ACCESSION NBR: 8507230262 DOC. DATE: 85/07/15 NOTARIZED: NO DOCKET #  
 FACIL: 50-315 Donald C. Cook Nuclear Power Plant, Unit 1, Indiana & 05000315  
 AUTH. NAME AUTHOR AFFILIATION  
 ALEXICH, M.P. Indiana & Michigan Electric Co.  
 RECIP. NAME RECIPIENT AFFILIATION  
 DENTON, H.R. Office of Nuclear Reactor Regulation, Director

SUBJECT: Requests relief from provisions of ASME Boiler & Pressure  
 Vessel Code Section XI, Subsection INC-5000 for auxiliary  
 spray to RCS & pressurizer. One, oversize drawing encl.  
 Aperture card available in PDR. Fee paid.

Donald C. Cook Nuclear Plant Unit No. 1  
Docket No. 50-315  
License No. DPR-58  
INSERVICE INSPECTION PRESSURE TEST-CODE RELIEF

DRW. NO. 1-5129-29

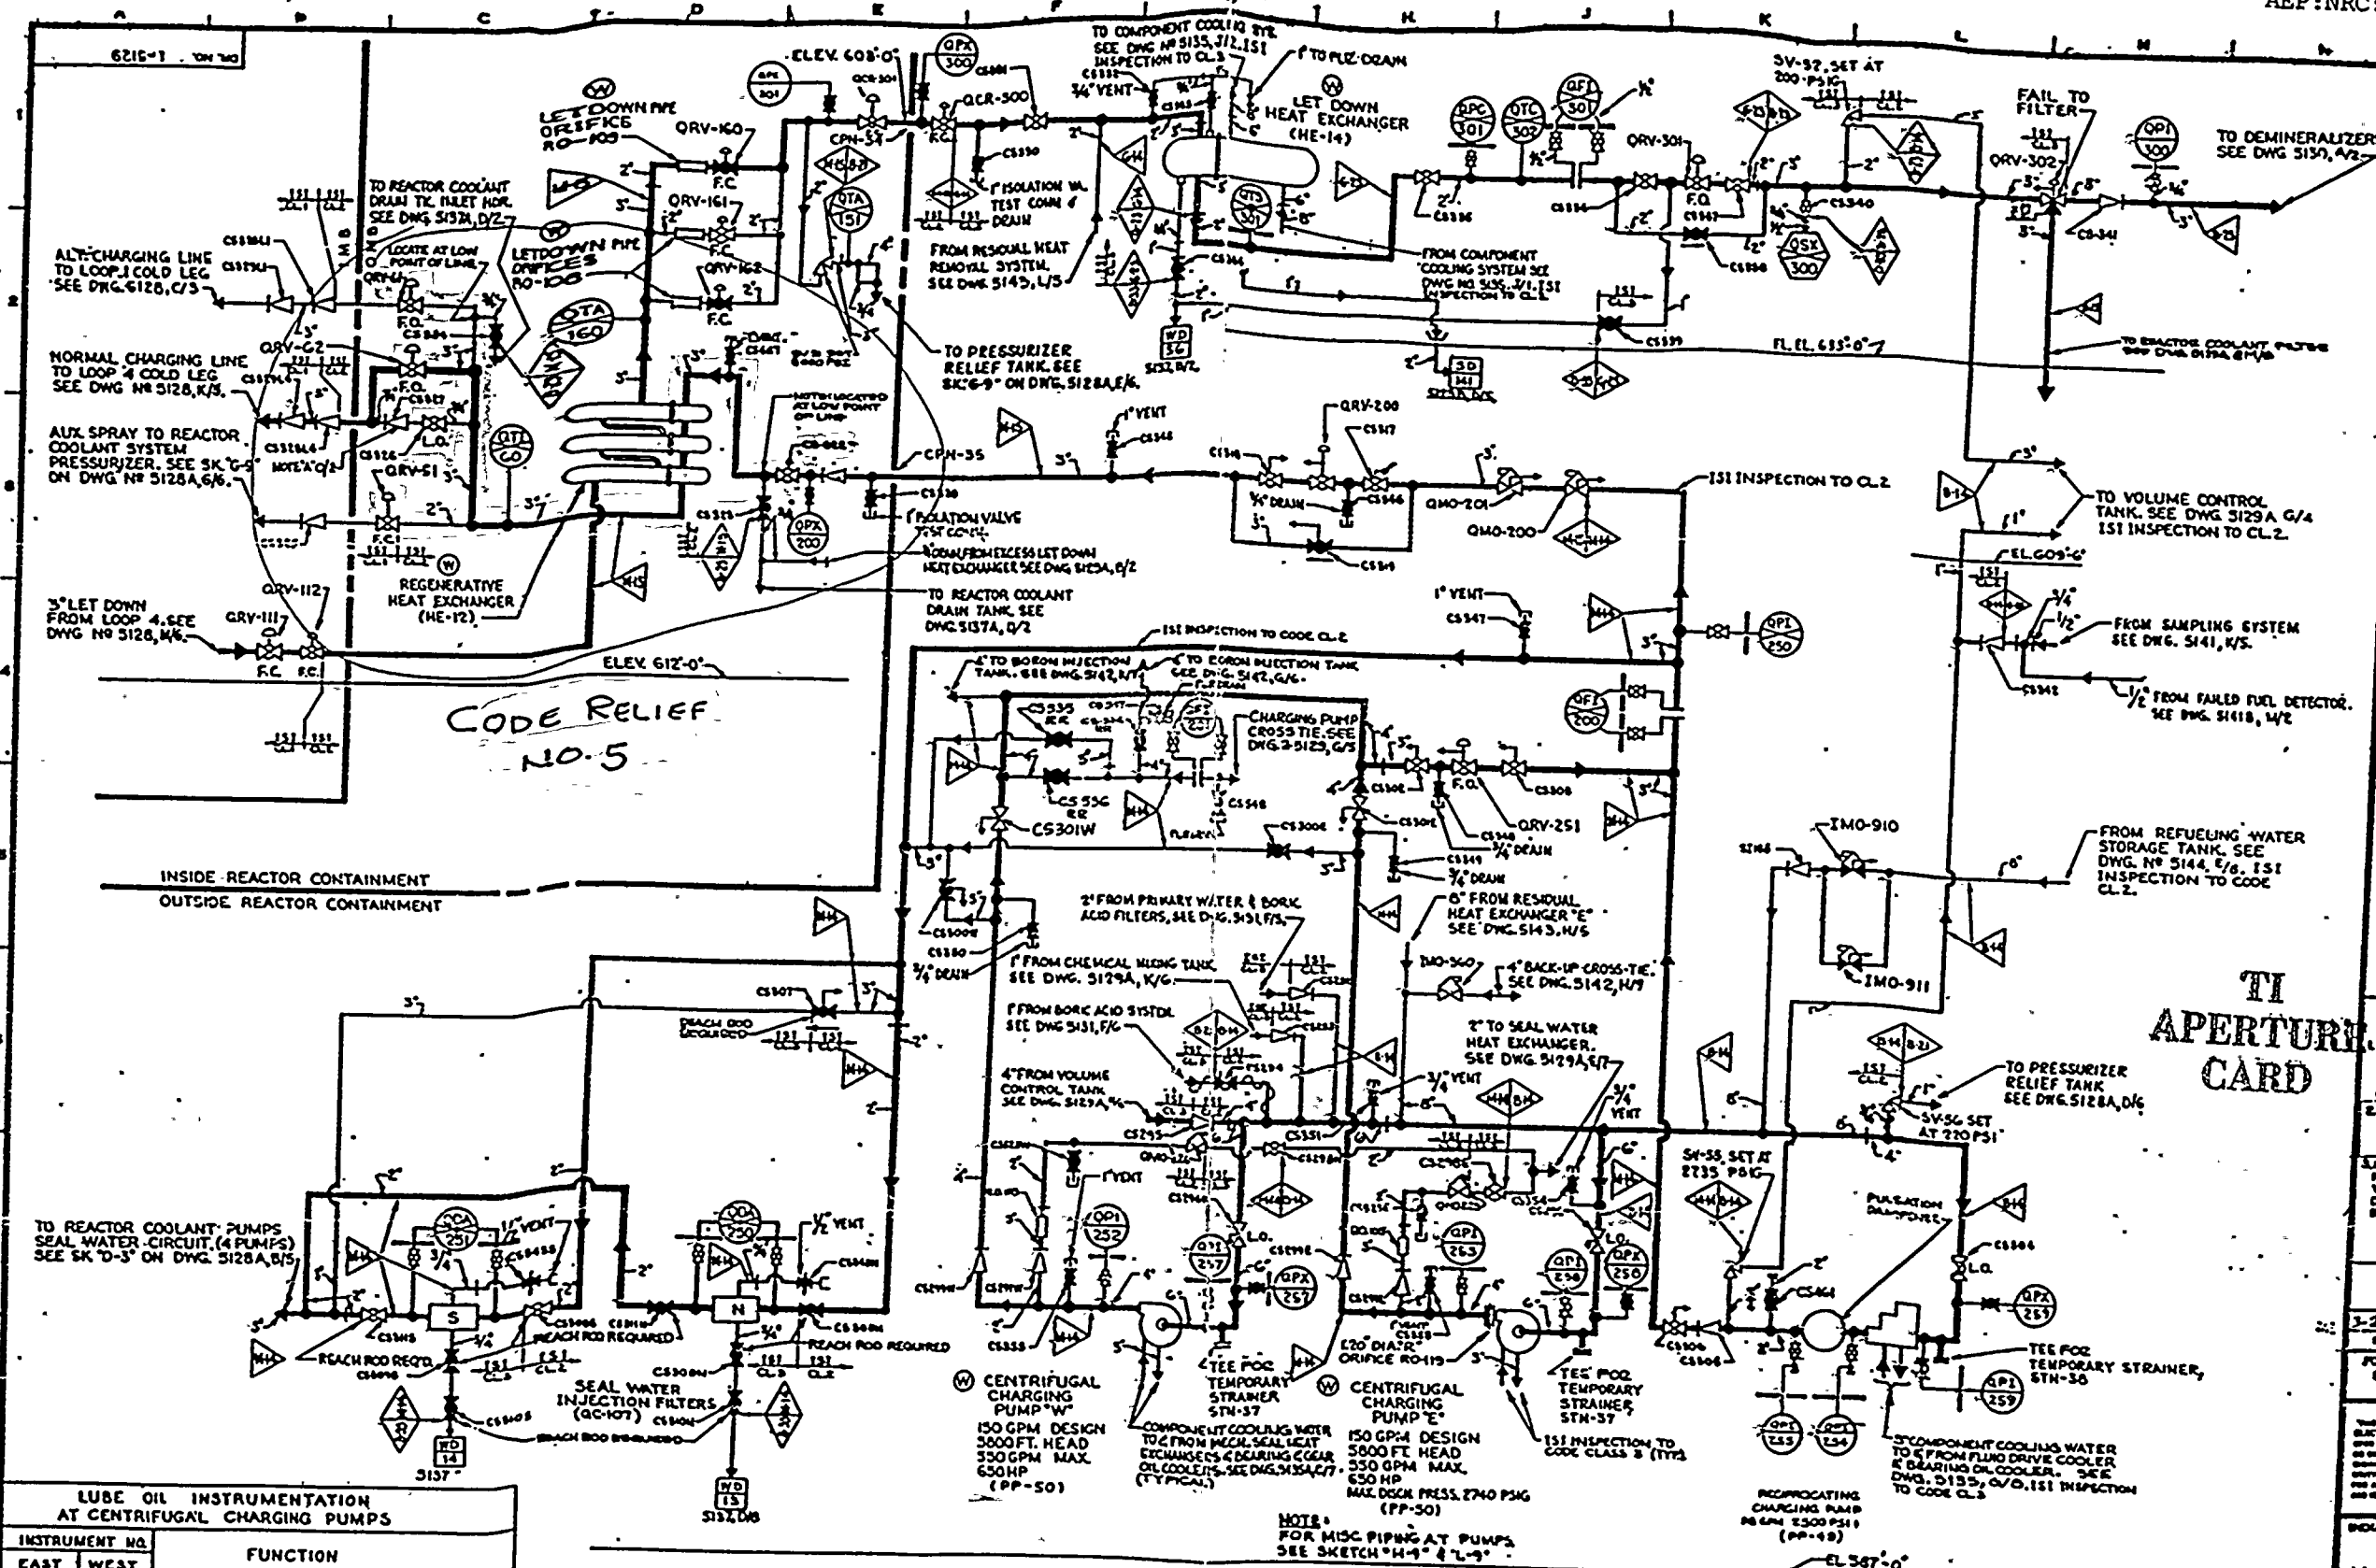
1. Auxiliary Spray to Reactor Coolant System and Pressurizer, CVCS - Reactor Letdown and Charging System, Drawing 1-5129

Valves QRV-51            CS-326  
Valves QRV-61            CS-322  
Valves QRV-62

For a design pressure of 2735 psig, Article IWC-5000 of the ASME Code, Section XI, requires that the piping be tested at a pressure of 3418 psig, and a temperature not less than 100°F.

It is proposed to test the above section of piping at a pressure of 2800 psig.

In order to perform the pressure test in this ISI Class 2 Section of piping, valve QRV-51 has to be used as an isolation valve. This 1,500 lb. class, air-operated, control valve is

designed to withstand a test pressure of 3418 psig in the open position. However, it cannot be used as an isolation valve because it was designed for a differential pressure of 1200 psig.

The valve cannot be kept closed during pressure testing at 3418 psig without extensive, temporary rigging. The modification would require: (1) removal of the air operator and installation of a "strong back" to keep the valve closed during the testing, (2) removal of the strong back after the testing, and (3) re-installation of the air operator on the valve and restoring the valve to operable condition before returning to service. The valve is located inside the re-generative heat exchanger room which is a very high radiation area and plant personnel would be subjected to radiation exposure of 5 to 7 man rems.

As an alternative, the possibility of using a freeze seal plug downstream of QRV-51 was considered. This would involve extensive working time in the Pressurizer Relief Tank area close to the pressurizer spray valves, which is a high radiation area. This alternative was rejected because plant personnel would be subject to an even higher radiation exposure of 8.5 man rems during the formation, monitoring, and removal of the freeze seal plug.

We believe that this is a reasonable code relief request since the proposed test pressure is in fact higher than the normal operating pressure of 2235 psig in the approximately 30 feet long section of piping for which code relief is requested.
